# Incremental Preliminary Design and Safety Review of the ePIC Hadron and Forward Electromagnetic Calorimetry

October 30<sup>th</sup> & 31<sup>st</sup>, 2025

The review covered the **design and performance** of these detectors with respect to the physics program and **requirements**, ranging from **construction and integration** to **operating conditions and background radiation**. This is an assessment of the readiness of these detector systems in particular towards the upcoming project reviews for **CD-2 (baseline)** for which the design maturity is expected to be 60% or higher.

## □ Technical performance

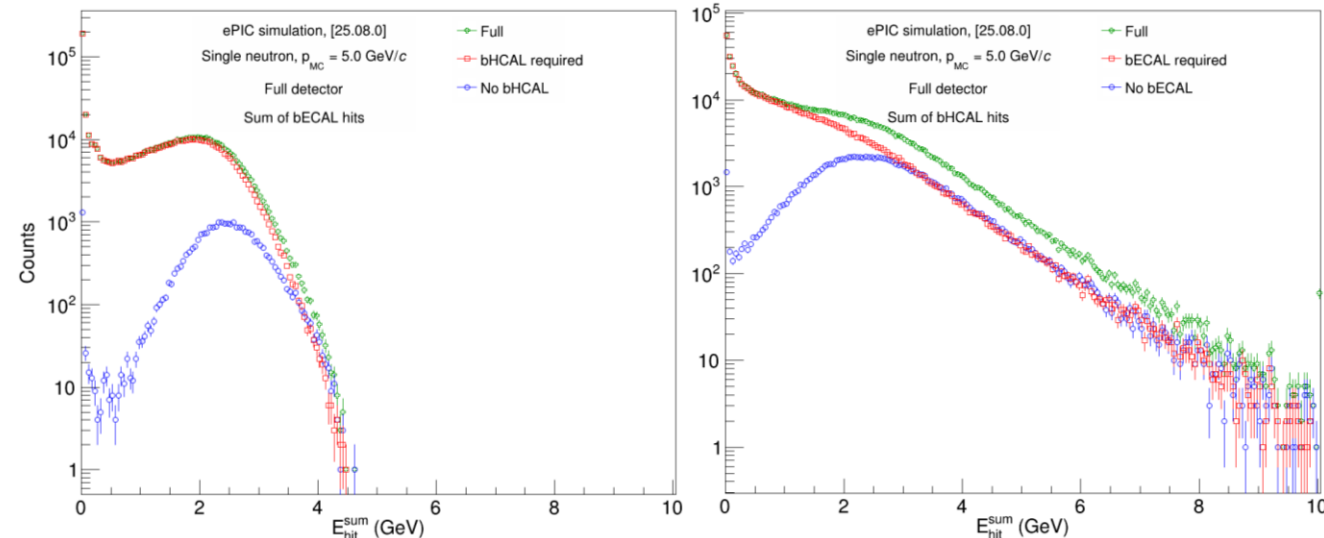
- Complex energy deposition system → requires detailed and comprehensive study
- Motivation for individual tile read-out is muon identification → Needs careful studies to demonstrate
